Product Change Notification

Change Notification #: 115100 - 00
Change Title: Intel® NUC Kit NUC5PGYH,
PCN 115100-00, Product Design, Label,
BIOS Update, Component Changes
Remove NFC header, add front panel
header and label Update
Date of Publication: November 17, 2016

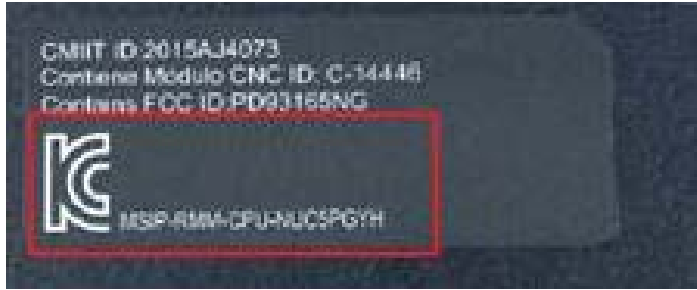
1. The BIOS will be updated from PYBSWCEL.86A.0054 to PYBSWCEL.86A.0057 for security enhancement. To access the release notes or get a copy of the BIOS for evaluation, go to <http://downloadcenter.intel.com>.
2. Remove the NFC header and add Front Panel header as part of the product enhancement.

Before

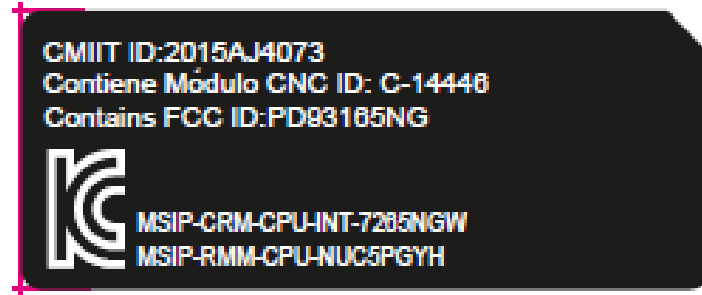
- Enhance WLAN label to add KCC ID to meet regulatory requirements.

The change to the label has no impact on the functionality of the product. Customer should be aware of the changes.
